**BEFORE THE PUBLIC UTILITY COMMISSION**

LC 73

PORTLAND GENERAL ELECTRIC  
COMPANY,

2019 Integrated Resource Plan.

FIGURE 7-13: Cost versus variability for the preferred portfolio

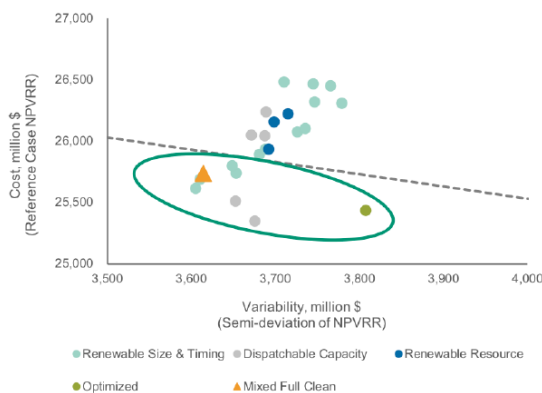
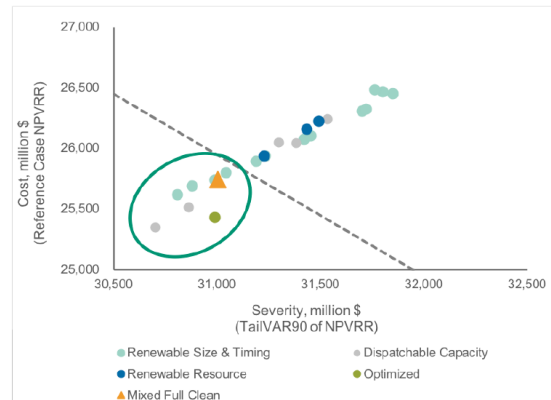
This approach to constructing a new preferred portfolio based on “reasonable actions” from other well performing portfolios is somewhat puzzling, and may present another blunt instrument in portfolio selection. Staff finds this approach particularly curious given that the Mixed Clean Full is outperformed by others in terms of cost and risk, as shown by PGE’s graphics:<sup>20</sup>

PGE should provide an analysis comparing its preferred portfolio to other top-performing portfolios for cost and risk, and explain why the Company believes it has chosen a portfolio with the best balance of cost and risk, as required by the IRP guidelines.

**Recommendation 4:** As PGE adjusts its IRP analysis in accordance with Staff's comments, including the removal on non-traditional screens, PGE should provide additional information:

- Provide a quantitative comparison of its preferred portfolio to other well-performing portfolios in terms of NPVRR cost and risk.
- Explain why the Company believes its preferred portfolio has the best balance of cost and risk for customers.

FIGURE 7-16: Estimated net impacts to retail power prices of Washington Wind additions

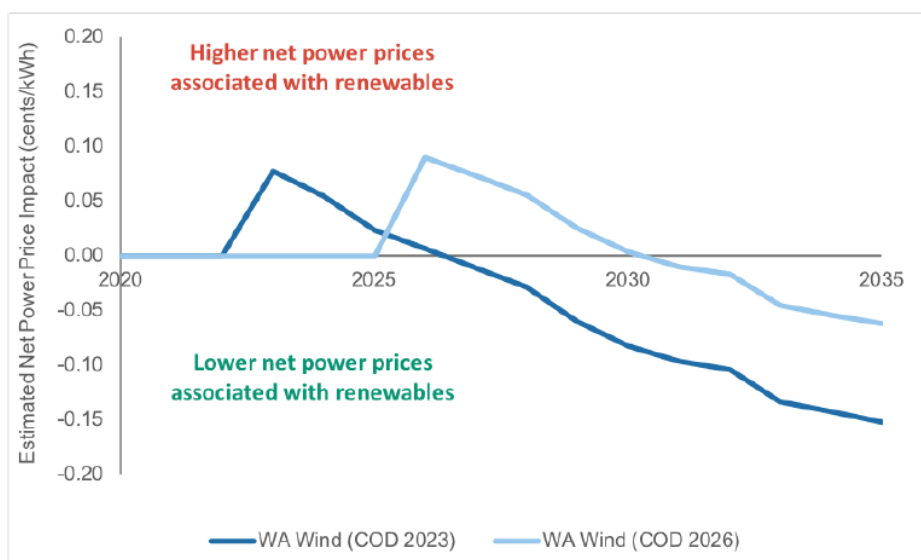
To place additional context on the analysis of a 2026 wind addition, PGE's Appendix G Load Resource Balance indicates that PGE may have an energy deficit by 2025.<sup>23</sup> Staff will conduct additional analysis to consider how the 0.01 cent difference in customer rates compares to the risk of an energy need in 2025, given other assumptions about load growth, voluntary programs, and new Qualifying Facility (QF) contracts that are discussed elsewhere in Staff opening comments.

Many factors could change the effect that a new resource will have on rates, including resource cost and performance, future market conditions, and future customer demand. Staff will continue to assess the inputs and assumptions behind PGE's intergenerational equity analysis. For example, the intergenerational equity analysis may utilize some of the same modeling inputs and assumptions that Staff finds concerning or problematic in the 2019 IRP. Staff hopes PGE will participate in a robust assessment and discussion of the intergenerational equity risks of near-term procurement of renewables.

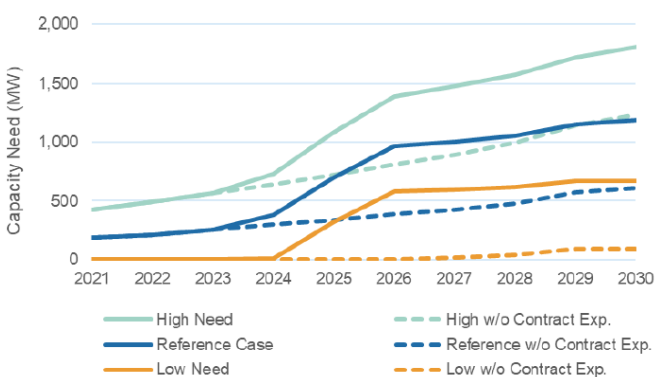
Staff is currently reviewing the forecasted range of capacity needs in the 2019 IRP, which it finds is strikingly broad. Staff is motivated to ensure that the Company gives adequate considerations to capacity adequacy, particularly given the robust discussions in Chapter 3 Futures and Uncertainties and the regional capacity need shown by recent studies evaluated in the Market Capacity Study.<sup>59</sup>

PGE forecasts wide “jaws” of capacity need by 2025, ranging from a low of 0 MW to a high of nearly 1,100 MW of new capacity. The graphic below captures the wide range of possible need.<sup>60</sup>

FIGURE 4-17: Load and existing and contracted generation

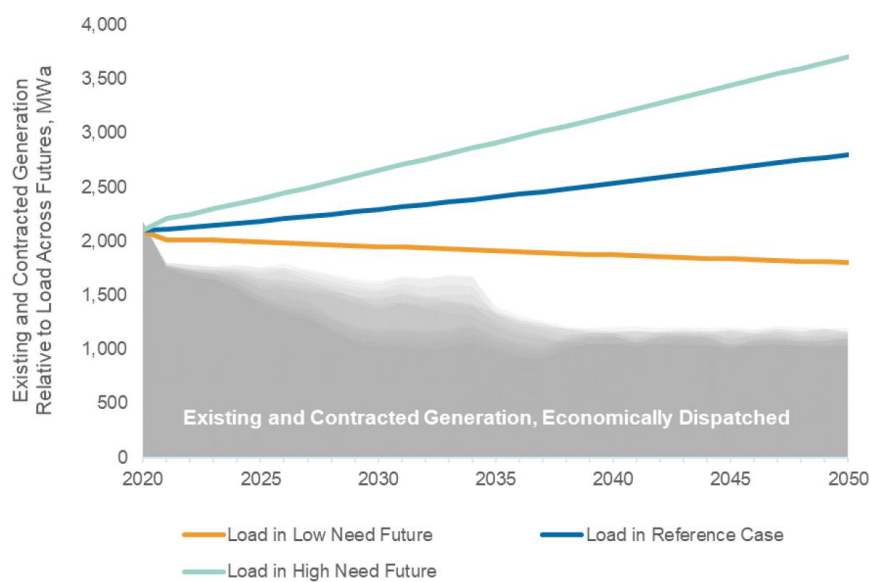
PGE’s new market energy position analysis provides an interesting evolution of the Company’s traditional load-resource balance. Through this analysis, PGE models economic dispatch and compares it to three need futures to demonstrate what it describes as an “energy shortage” (See Figure 4-17).<sup>66</sup>

Yet, when PGE’s resources dispatch economically and market purchases meet the rest of PGE’s load, this is not necessarily an indication that PGE needs to acquire more energy resources. It may simply indicate that market prices are low. PGE’s ‘Market Energy Position’ analysis tells how much energy the company may choose to buy on the market, but in no way should it be used to justify any amount of new resource acquisition.

In a data response to Staff, PGE clarified that its portfolio modeling uses the market energy position to constrain overbuilding of new resources and to calculate GHG emissions, but not to identify when there is a need to add a new resource.<sup>67</sup> Staff appreciates the Company’s clarification. Staff would have serious concerns with portfolio modeling that bases its energy need on its market price forecast and resulting economic dispatch model.

**FIGURE 6-2: Levelized cost of energy (LCOE) of energy resource options**

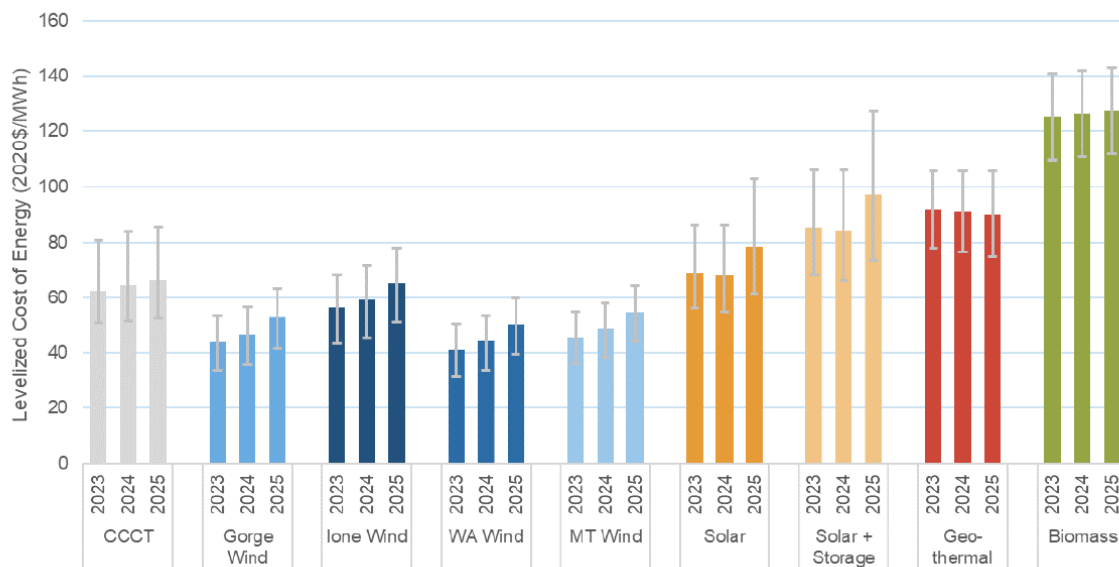
Staff finds this statement generally true and believes the IRP does a good job of demonstrating the production risk associated with capacity factor sensitivity in Section 6.5.<sup>82</sup> However, Staff would like to better understand how the many assumptions underlying this conclusion were captured in the portfolio modeling and selection. Given that the main driver for the near-term acquisition of wind resources is not energy, capacity, or an RPS need, but rather the time-limited economic opportunity associated with expiring PTCs, Staff’s review is focused on understanding the Company’s assumptions around the federal tax incentives and overall performance of renewable energy resources compared to conventional resources (See Figure 6-2 below).<sup>83</sup>

FIGURE 6-15: Net cost sensitivities for wind

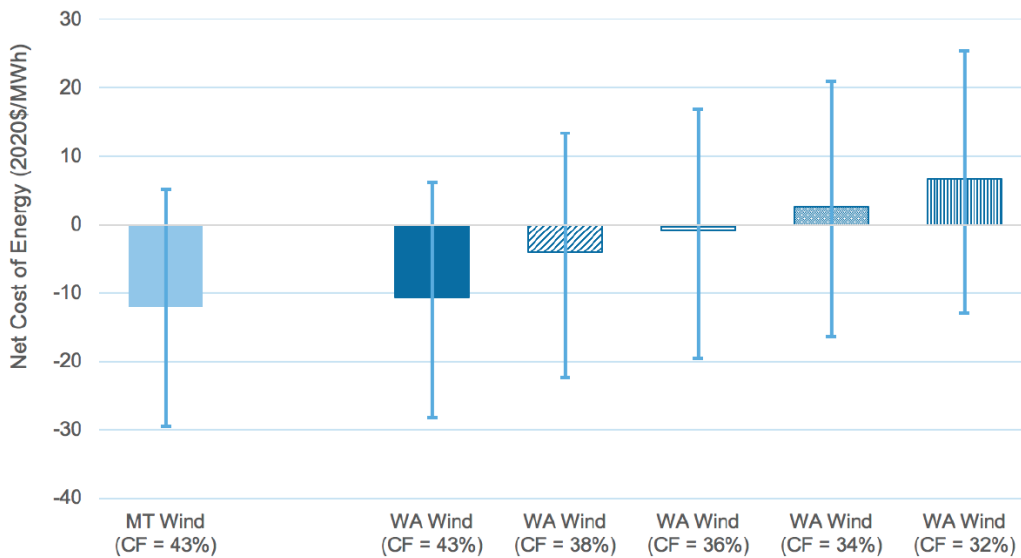
Staff particularly appreciates the sensitivity analysis for wind capacity factors provided in Section 6.5 and Figure 6-15 below.<sup>89</sup>

Staff notes the impact that capacity factor assumptions have on the economic performance of wind resources in PGE’s sensitivity and questions whether the Company’s sensitivity analysis should have been performed on the Mixed Full Clean portfolio to help characterize the risk of acquiring near-term wind assets based primarily on economic performance.

**Recommendation 20:** Staff requests that PGE provide a sensitivity analysis of the Mixed Full Clean portfolio assuming proportionate changes to the capacity factor of each resource as the assumptions behind the capacity factor sensitivity analysis in Figure 6-15 above.

**FIGURE 5-4: Average monthly wind capacity factors by location**

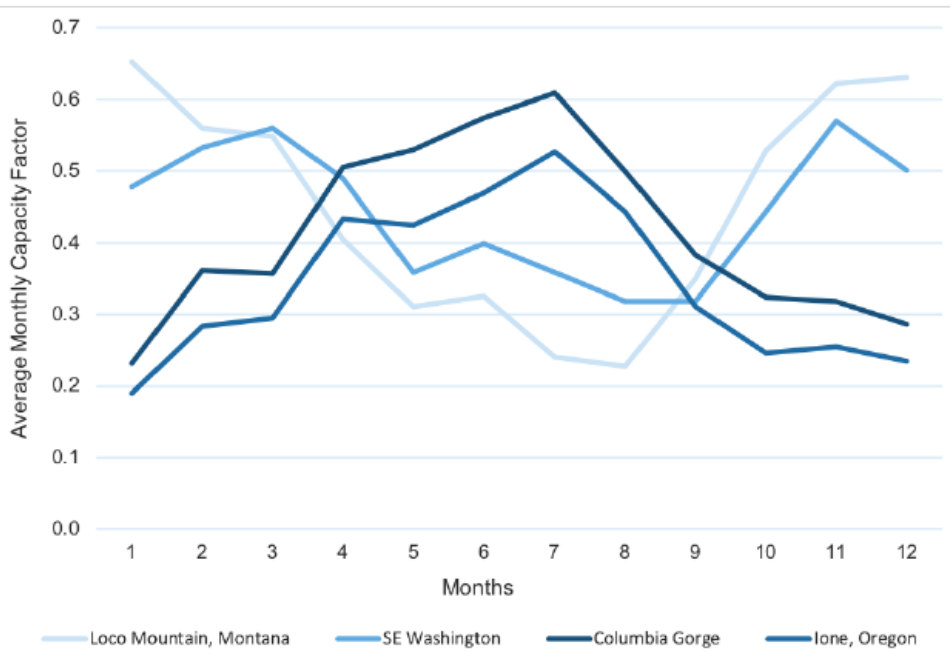
Further, Staff is curious about the relationship between the capacity factor shape of different wind resources modeled in the IRP and PGE’s projected capacity needs. For example, PGE provided a helpful characterization of different wind resources’ capacity factor shapes in Figure 5-4.<sup>90</sup> Staff notes that the performance of Columbia Gorge and lone, Oregon wind follow the reverse shape to that of Montana and Washington wind.

**FIGURE 4-14: Reference Case loss-of-load expectation in 2025**

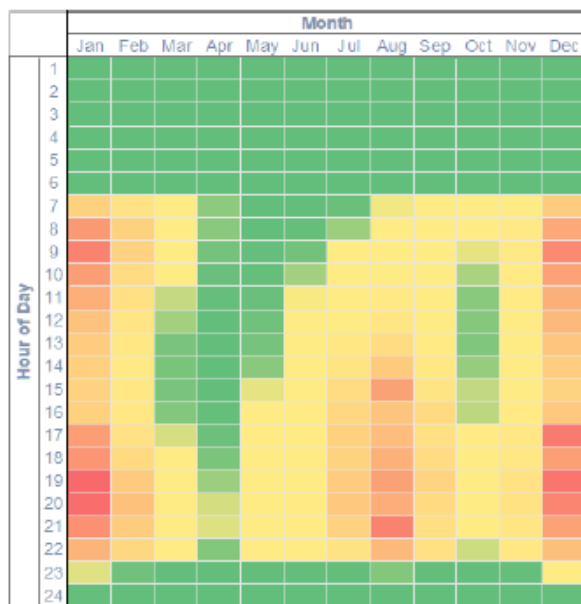
Given the Action Plan’s lack of specificity regarding resources in the renewable RFP and the future capacity actions, it is particularly interesting to note the relationship between the wind shapes and PGE’s characterization of its capacity need found in figure 4-14.<sup>91</sup>
